# Work Order ID 90174

Item Name: Modified Latch Mechanism, LH

# DART SERVICE INSTRUCTION

TO AMEND INSTALLATION INSTRUCTIONS IIN-D412-761 REV. D  
INSTRUCTION FOR CONTINUED AIRWORTHINESS ICA-D412-761 REV. 1  
AND INSTALLATION DRAWING D412-761-1 REV. D

**VIEW G**  
(FROM SHEET 7 OF INSTALLATION DRAWING D412-761-1)

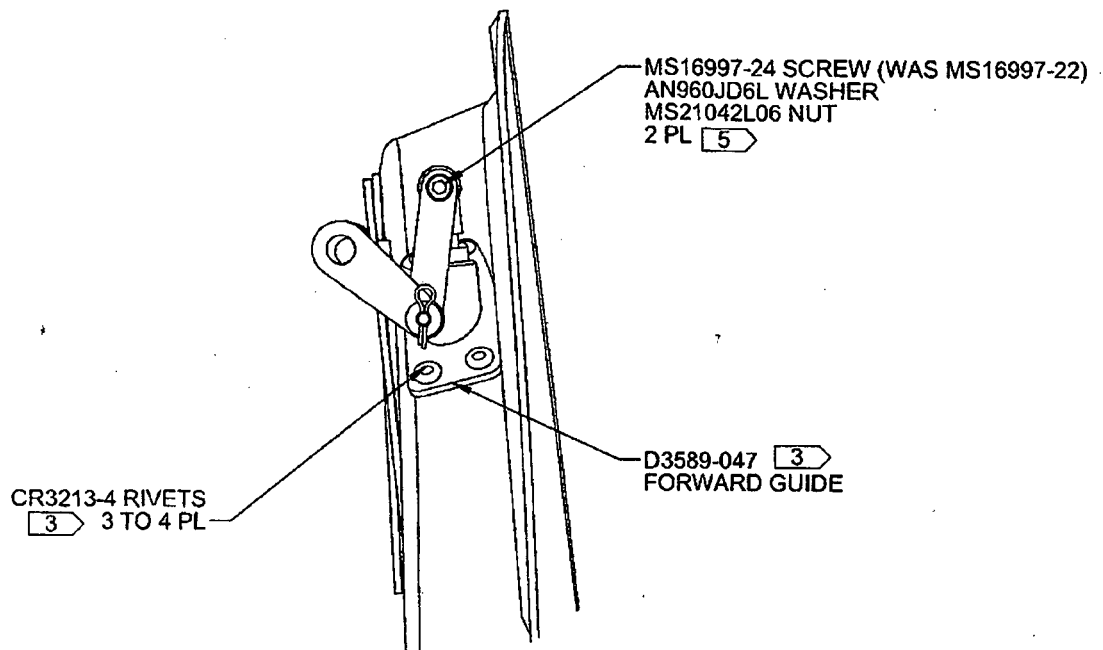
The purpose of this service instruction is to replace the MS16997-22 screw used in the latch assembly with MS16997-24 screw.

2				MS16997-22	SCREW
--	---	--	--	--	------------	-------

2				MS16997-24	SCREW
--	---	--	--	--	------------	-------
